Access Compliance Report Public Rights-of-Way (Curb Ramps)

Main Street: SHADOW_HILL_DR Cross Street: KENTWATER_PL Location: SE

ADA ID: RPAT210922134211 Ramp Type: Type 1 - Perpendicular Diagonal Initial Pass/Fail: Pass Overall Compliance: No Severity Score: 6

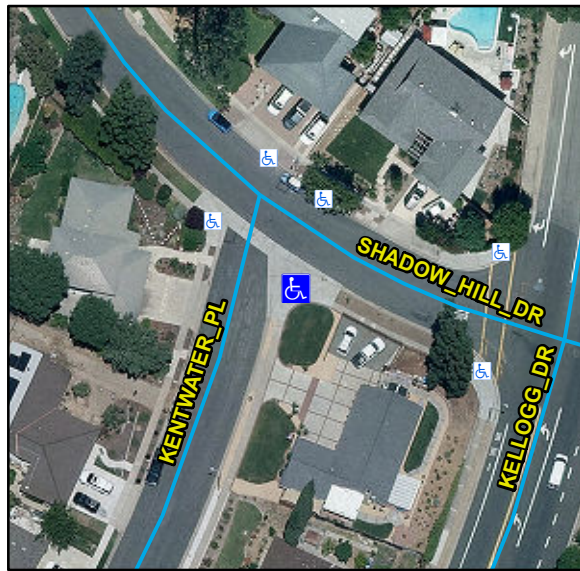
R304.2.2, R304.5.3, R304.2.1, STD 1115

Compliance	Description	Data	Compliance	Description	Data
N/A	Ramp Length (in)	58	N/A	Flare Type LT	
Yes	Ramp Width (in)	48			Sloped
Yes	Ramp Run Slope (%)	7.4	Yes	Flare Slope LT (%)	6.5
No	Ramp Cross Slope (%)	3.4	N/A	Flare Traversable LT	Yes
N/A	Landing Present	Yes	N/A	Flare Type RT	
N/A	Landing Length (in)	46			Sloped
Yes	Landing Width (in)	48	Yes	Flare Slope RT (%)	2.1
Yes	Landing Run Slope (%)	1.7	N/A	Flare Traversable RT	Yes
No	Landing Cross Slope (%)	3.2	Yes	DWS Provided	Yes
N/A	Landing Movement Obstructed?	Yes	Yes	DWS Contrast	Yes
	Landing Movement Type	Curb	Yes	DWS Length (in)	36
N/A	Landing Shared	No	Yes	DWS Full Width	Yes
N/A	Clear Space	Yes	Yes	DWS Offset Left (in)	0
N/A	Clear Space To Crosswalk (in)	48	Yes	DWS Offset Right (in)	N/A
N/A	Marked Crosswalk 1	No	N/A	Marked Crosswalk 2	No
	Crossing 1 Direction	NE		Crossing 2 Direction	NW
	Marked Crosswalk 1 Width (in)	N/A		Marked Crosswalk 2 Width (in)	N/A

Remove & Replace Curb Ramp With Two New Directional Ramps or Equivalent.
